To: T10 Technical Committee
 From: Rob Elliott, HP (elliott@hp.com)
 Date: 26 April 2006
 Subject: 06-189r1 SAS-2 Allow table-to-table expander attachment

Revision 1 (26 April 2006) Incorporated comments from 20 April 2006 SAS-2 zoning WG - got rid of edge expander/fanout expander designations and edge expander device sets altogether.

Figure 5 — Maximum Expander device-set topology example

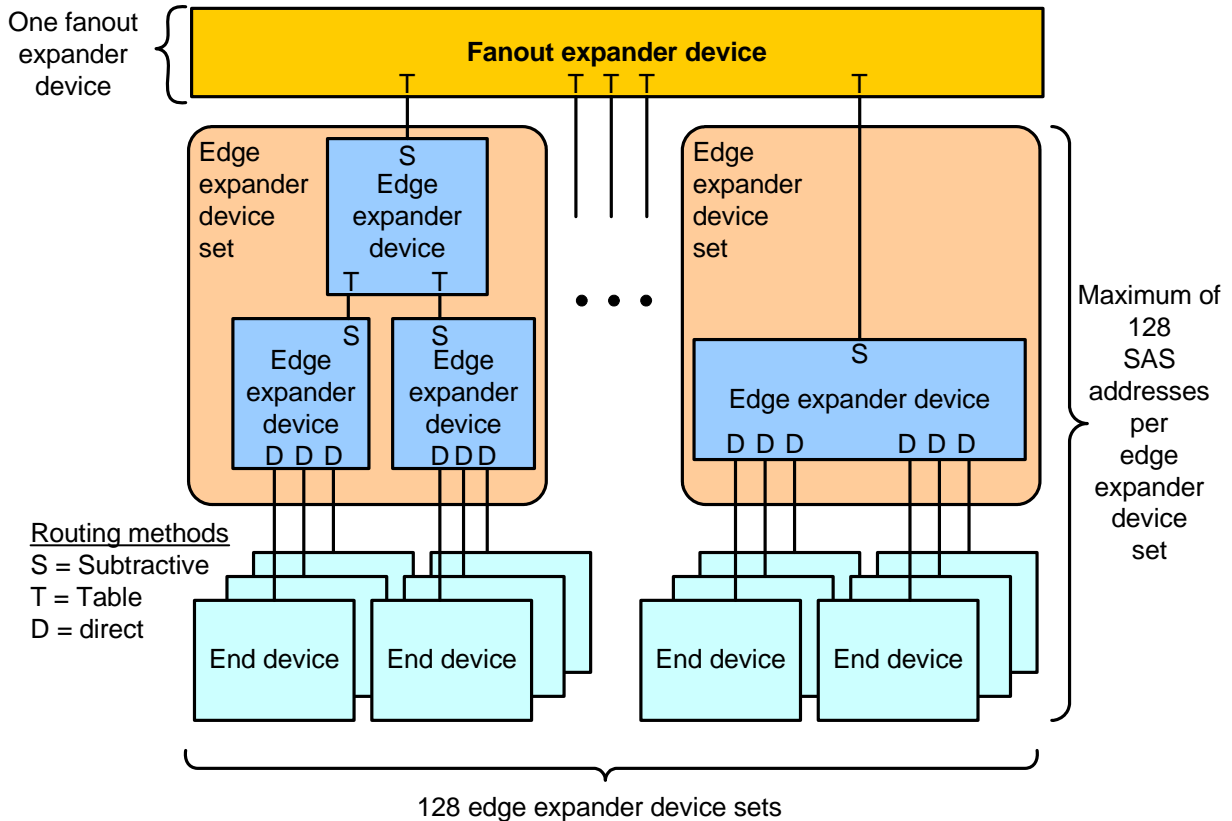
Editor's Note 2: this figure needs to be modified to get rid of edge/fanout terms. More example figures are needed showing upstream table phys and other interesting topologies now allowed.

Figure 9 — Level-order traversal example

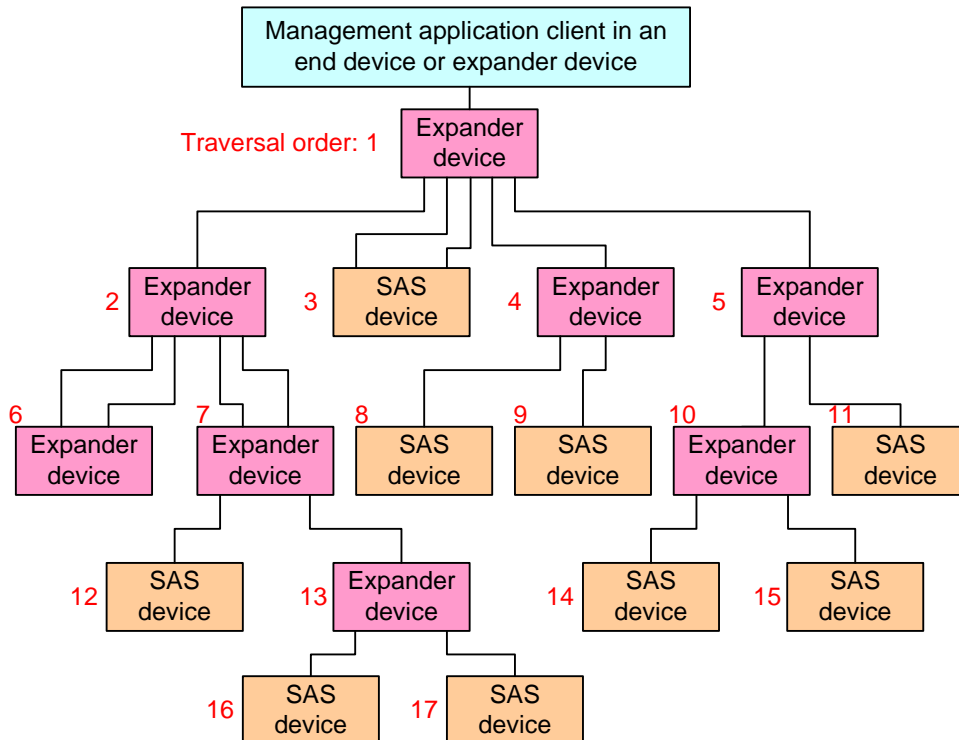
Editor's Note 6: Change "or expander device" to "or self-configuring expander device" in the figure

Figure 11 — Externally configurable expander device and table-to-table attachment

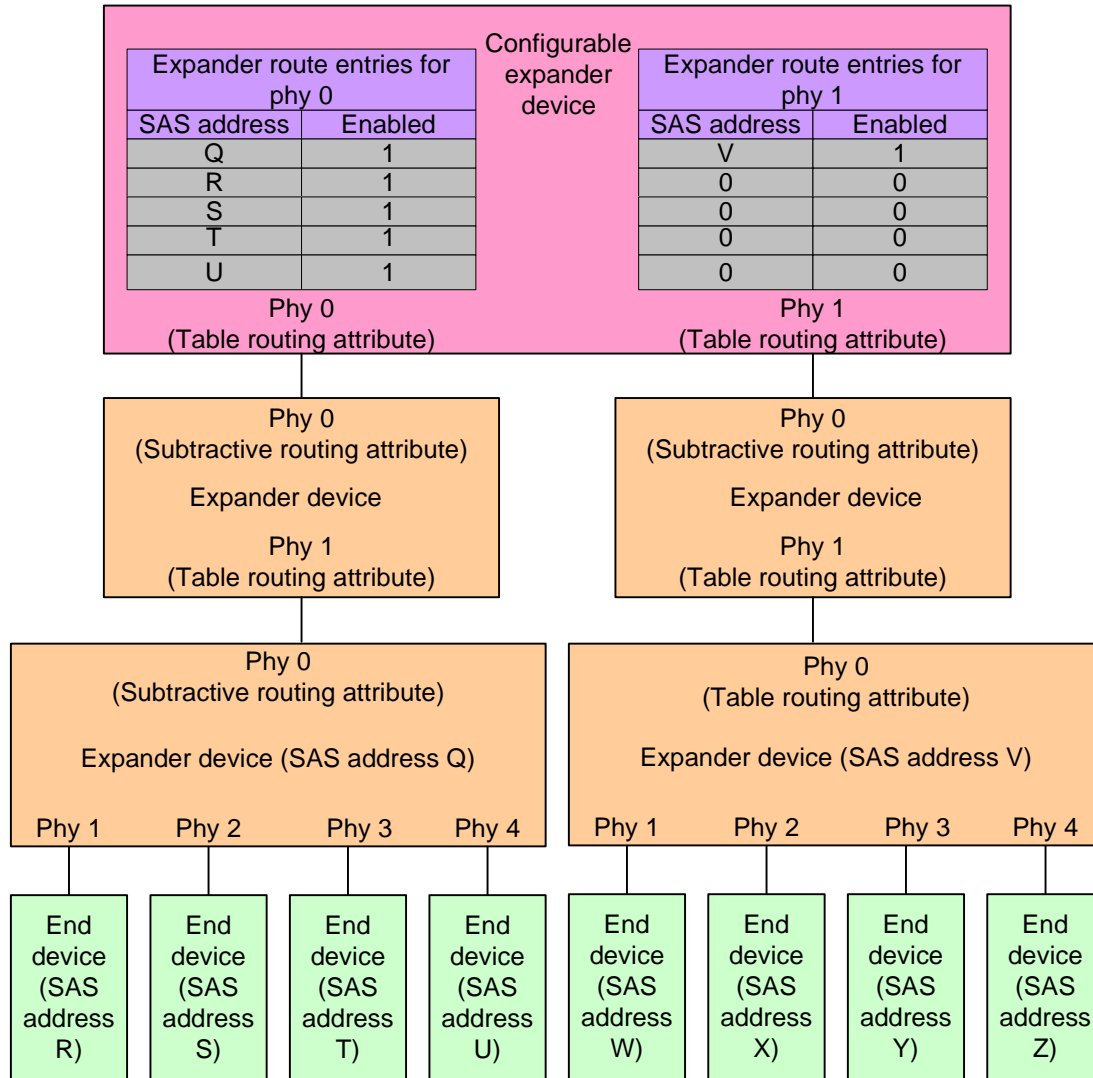
Editor's Note 7: add note that W, X, Y, and Z are not put in the table on the right. Therefore, R, S, T, and U are not able to access W, X, Y, and Z.

Editor's Note 8: add: NOTE This provides compatibility with SAS-1.1 devices. Configurable expander devices in a domain containing table-to-table attachments may not allow all devices to establish connections to each other. SAS domains containing only self-configuring expanders

Editor's Note 9: show a red line showing a connection from R that is not able to go through
